WAYII AREA TRAIL DESIGN INDEX SHEET

--	----	----
--	----	----
--	----	----
--	----	----
1	REVISED REST AREAS	21/03/10
0	ISSUED FOR TENDER	21/02/18

TOFINO
**PACIFIC RIM
NATIONAL PARK RESERVE**
ʔapsčik tašii
(Ups-cheek ta-shee)
**“Going in the right
direction on the trail”**

WAYII AREA TRAIL DESIGN

Drawing title/Titre du dessin
WAYII AREA TRAIL DESIGN
TRAIL SECTIONS
STA 0+380 TO STA 0+400

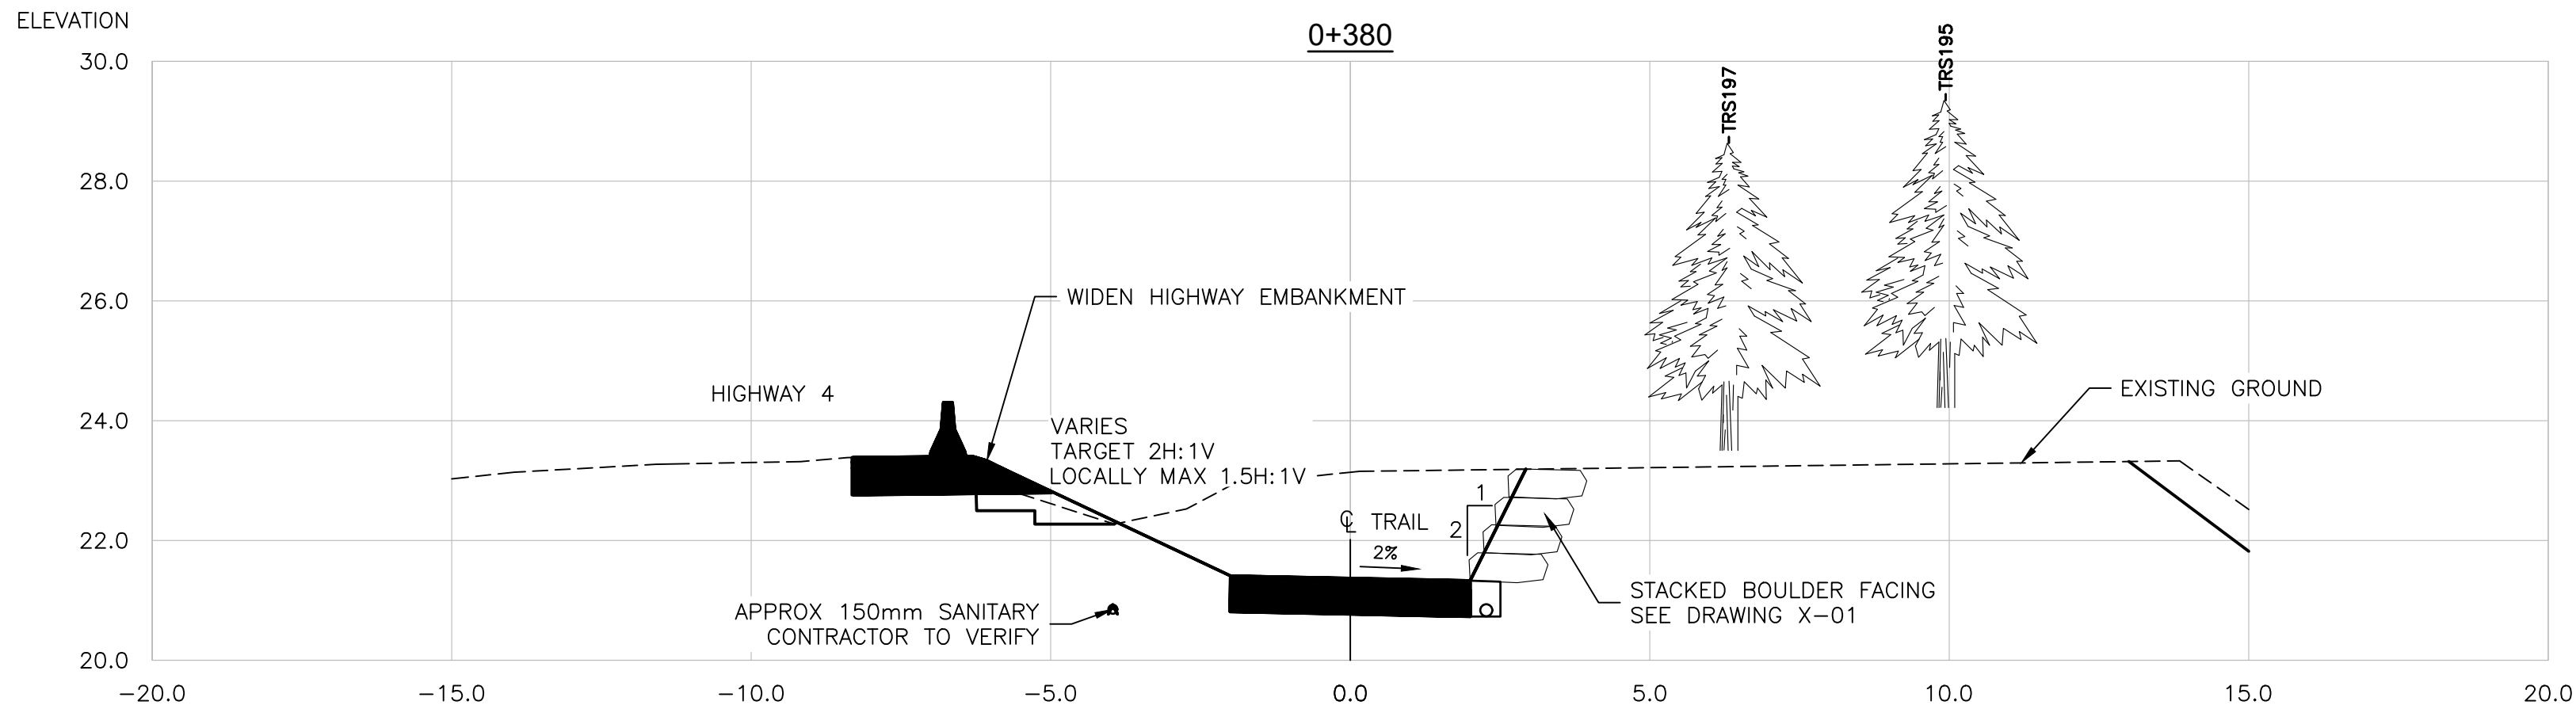
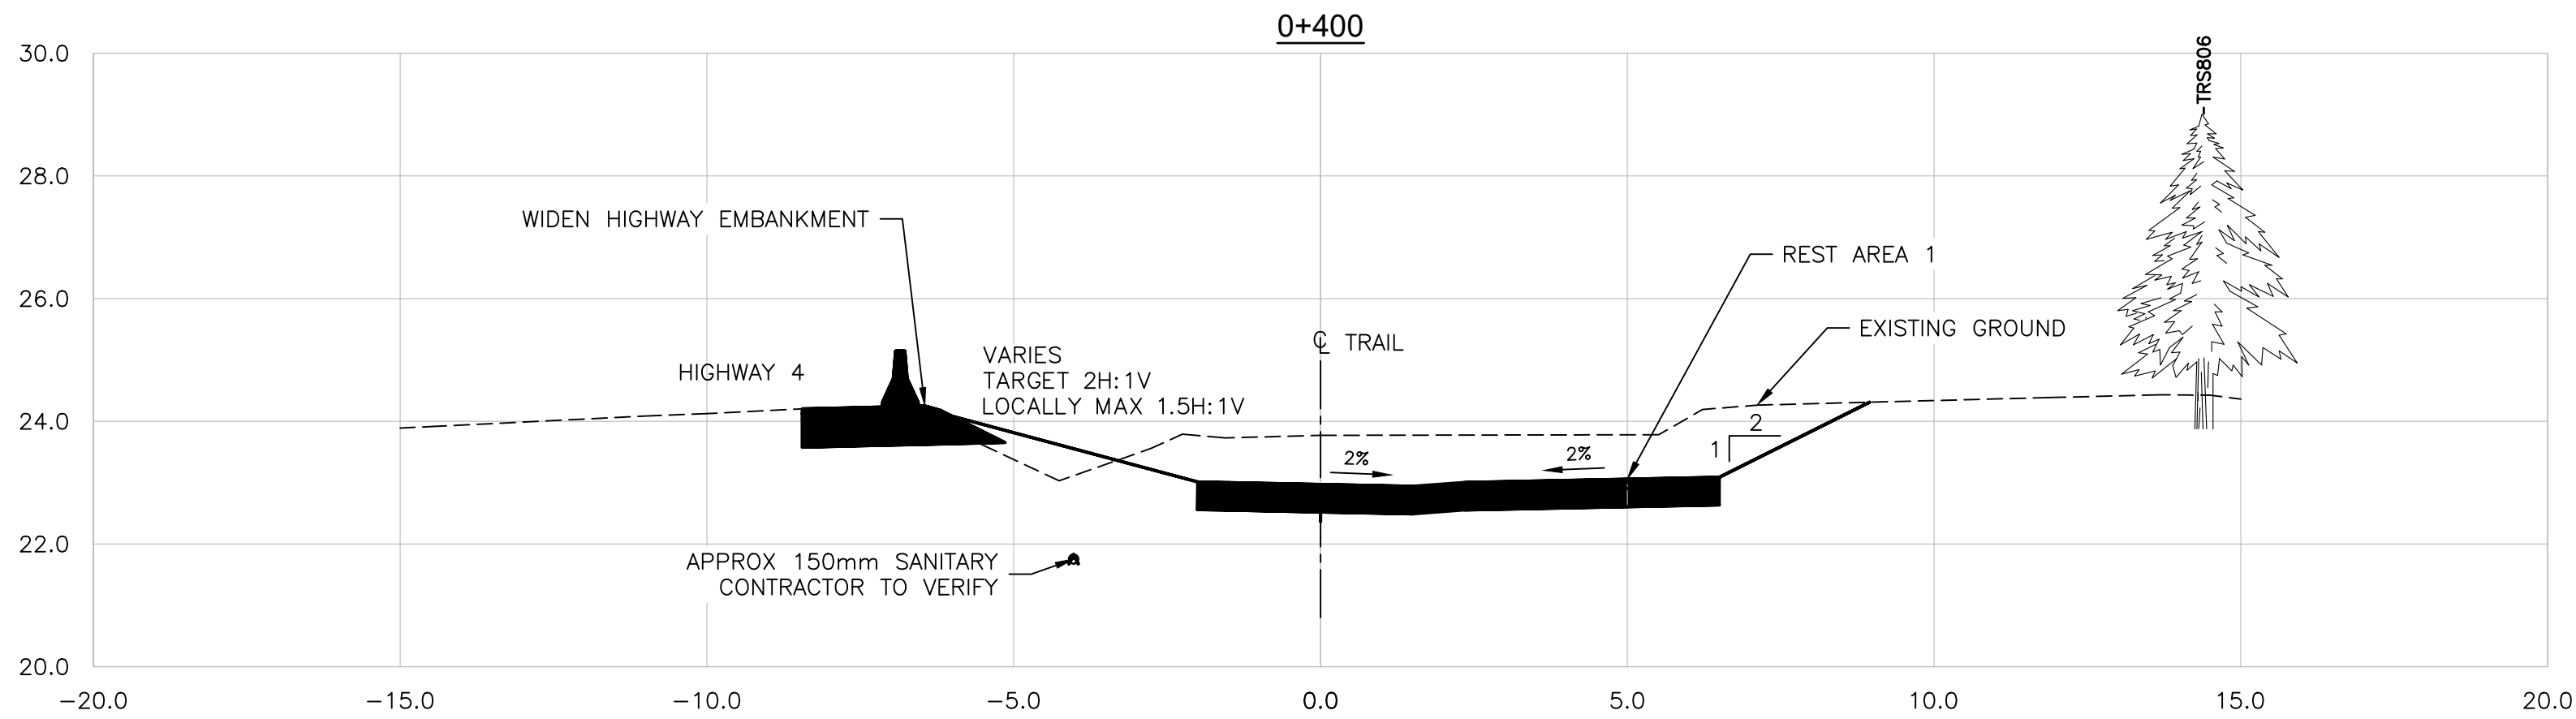
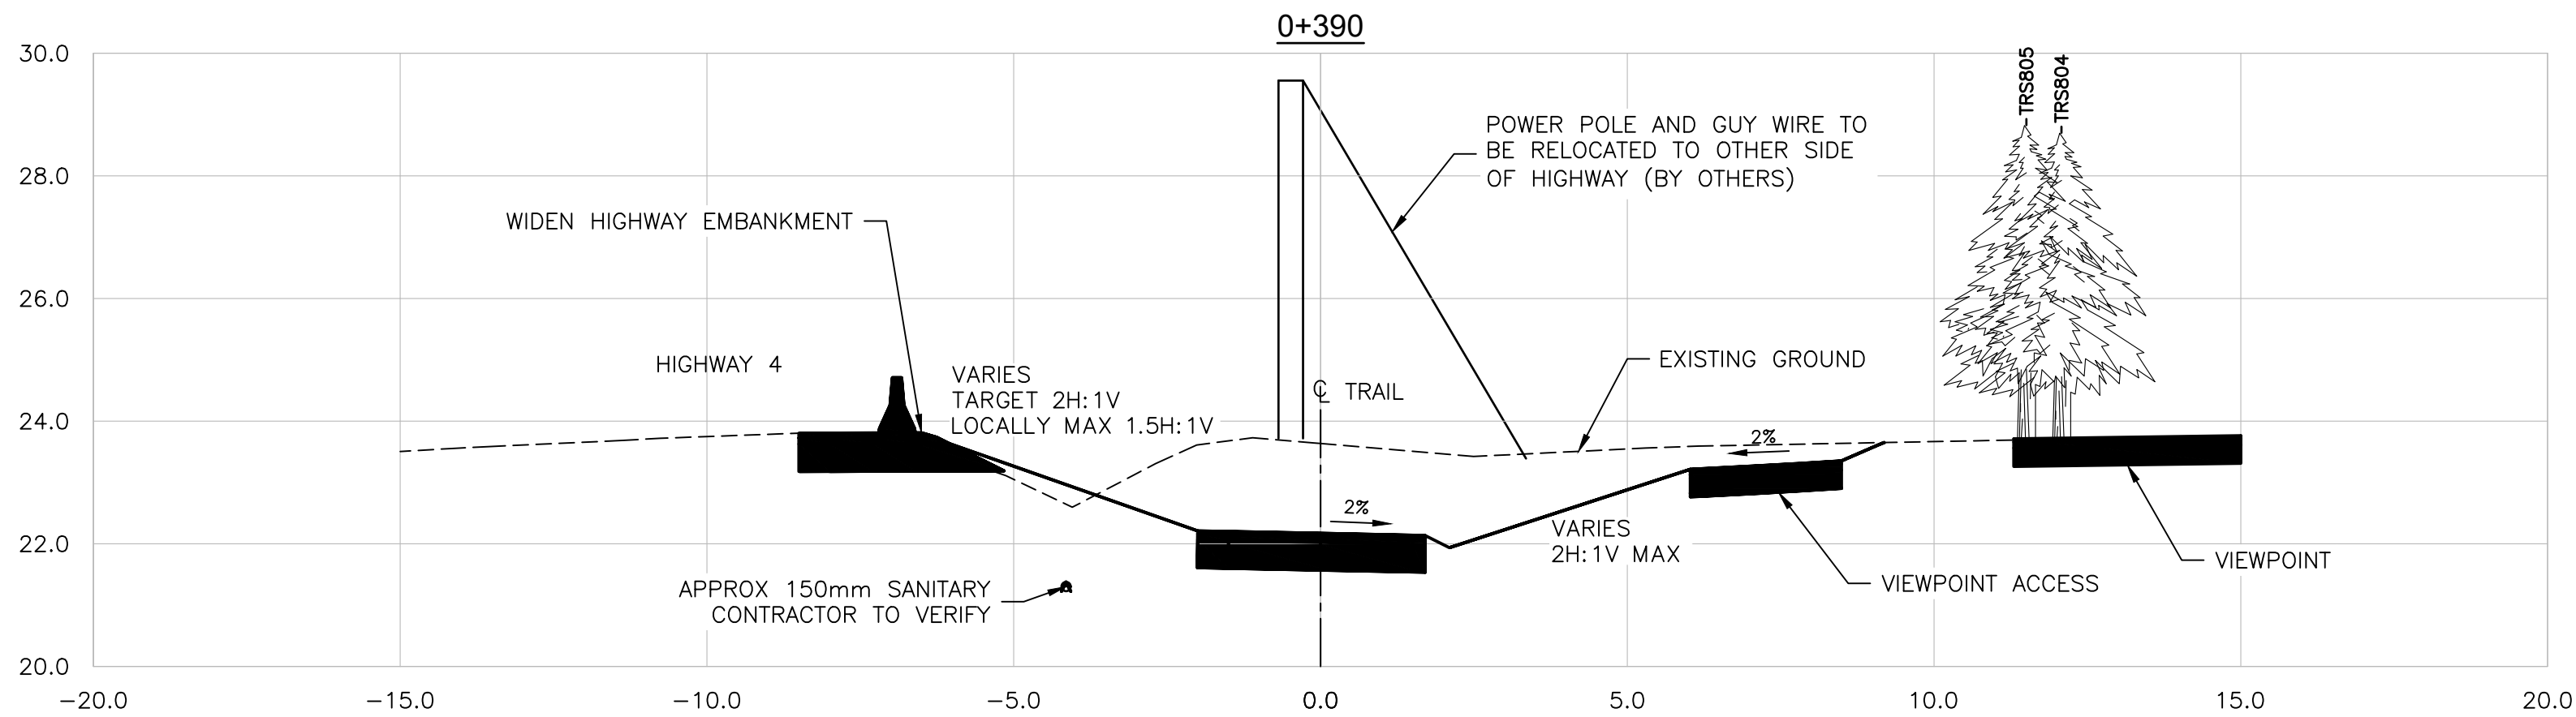
1. REVISED R1 AND
RELATED ADJUSTMENTS
TO TRAIL ALIGNMENT

Drawing title/Titre du dessin
WAYII AREA TRAIL DESIGN
TRAIL SECTIONS STA 0+437 TO STA 0+460

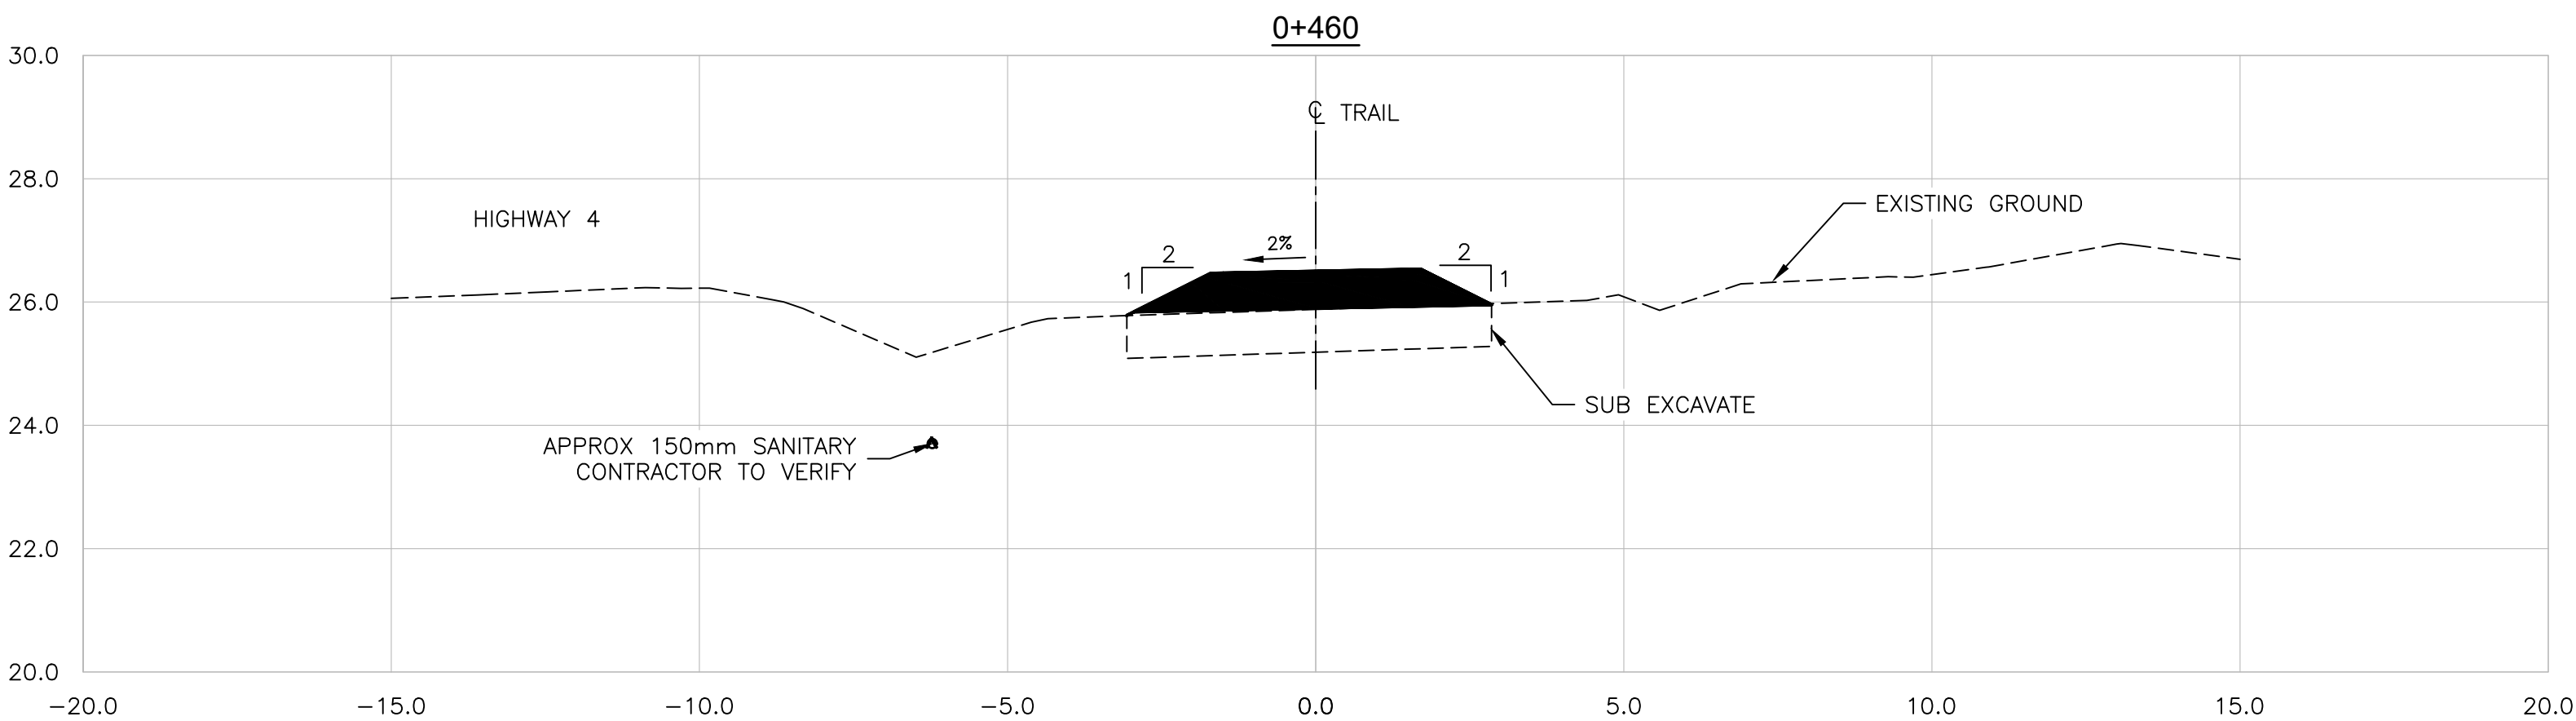
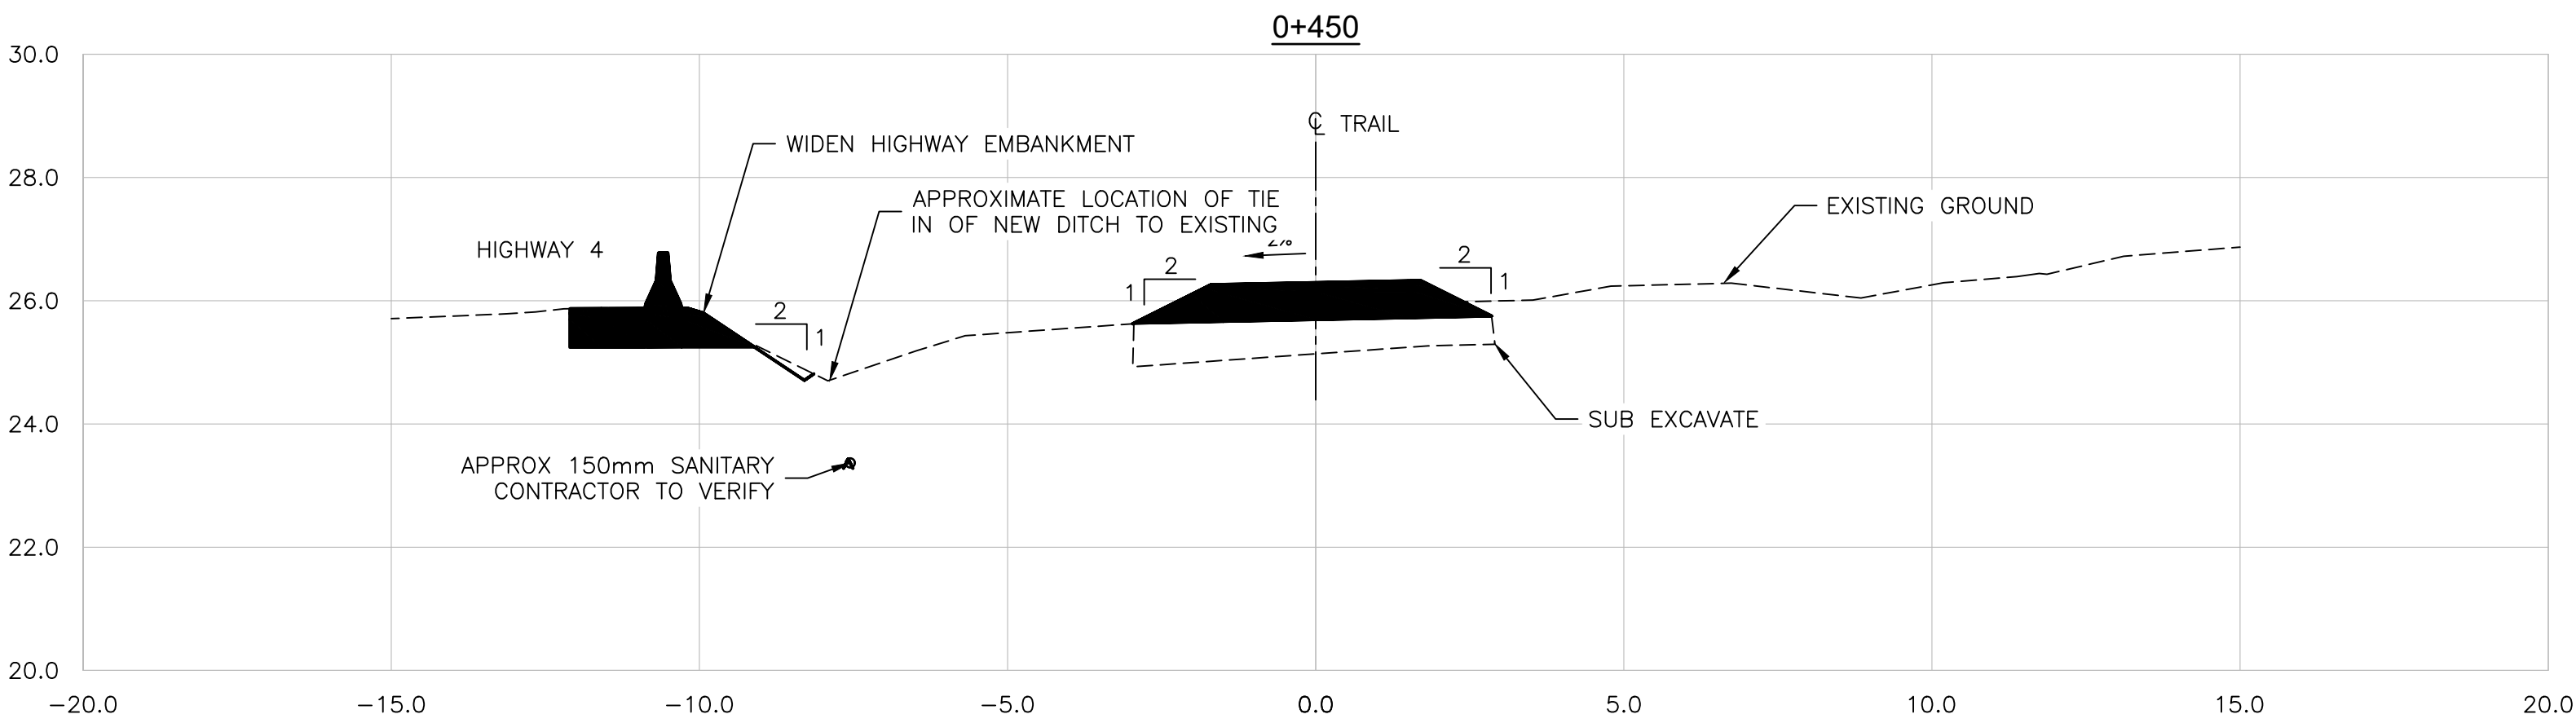
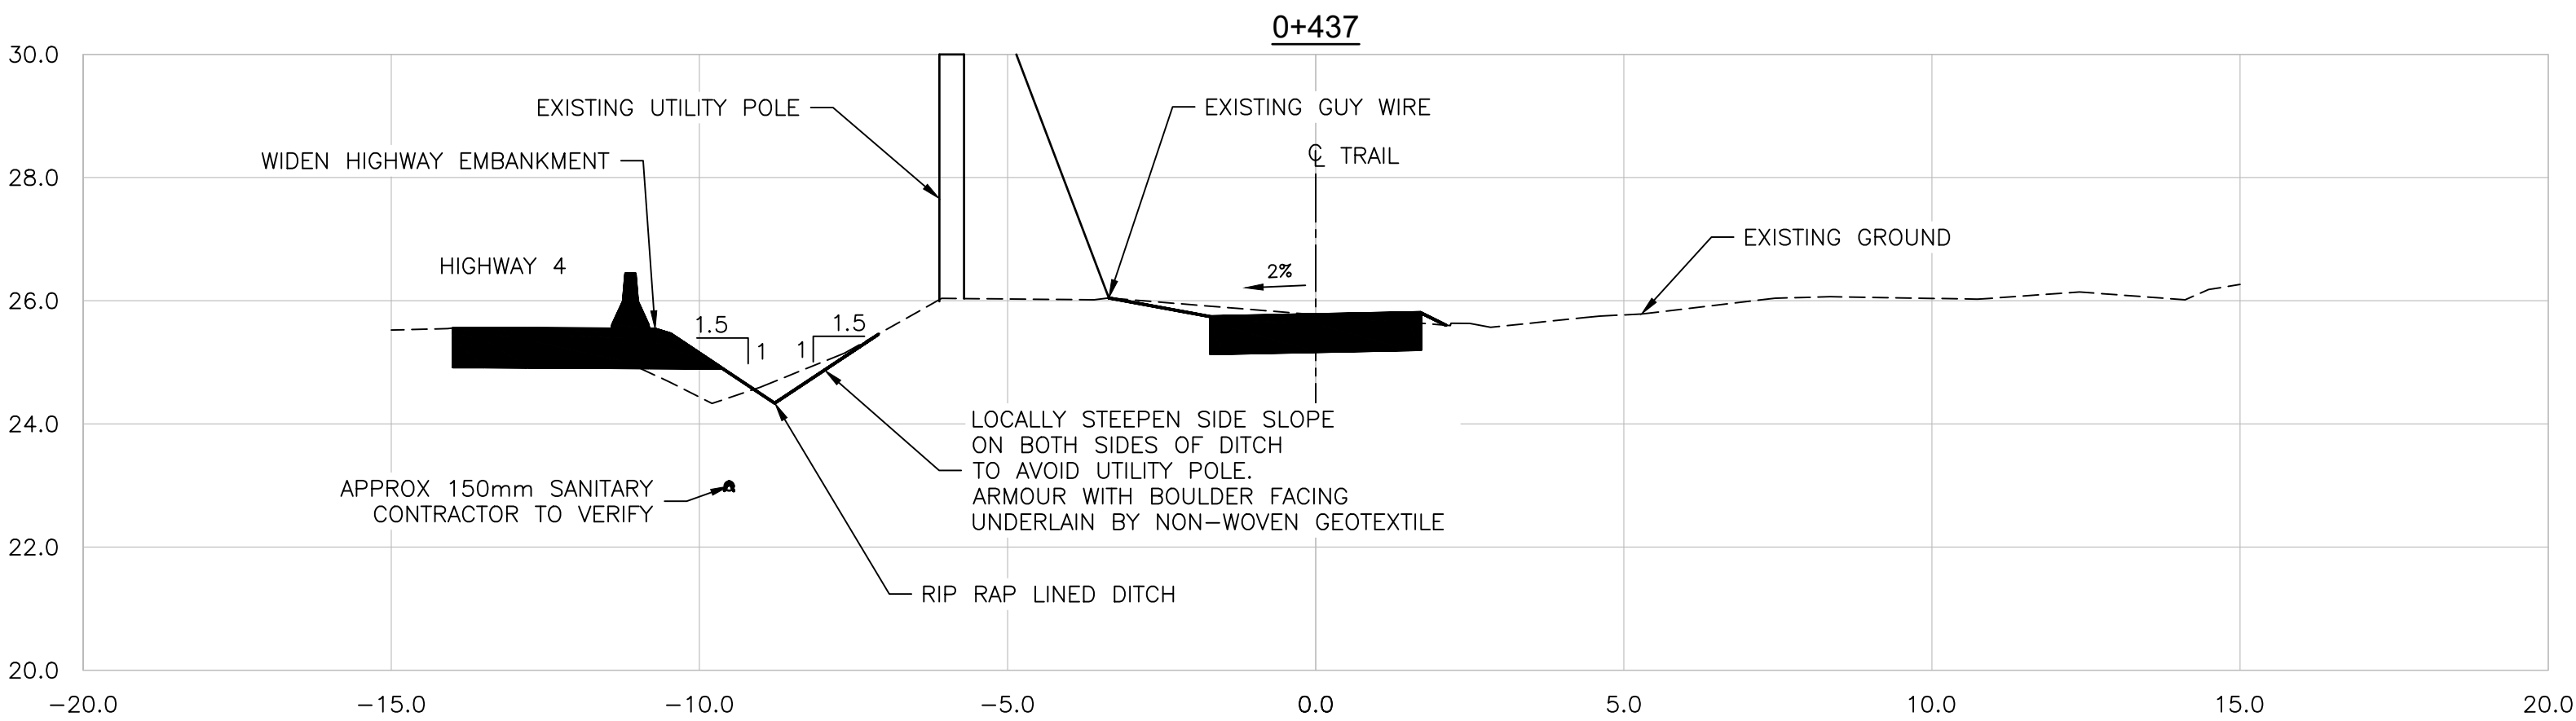
1
REVISED R1 AND
RELATED ADJUSTMENTS
TO TRAIL ALIGNMENT
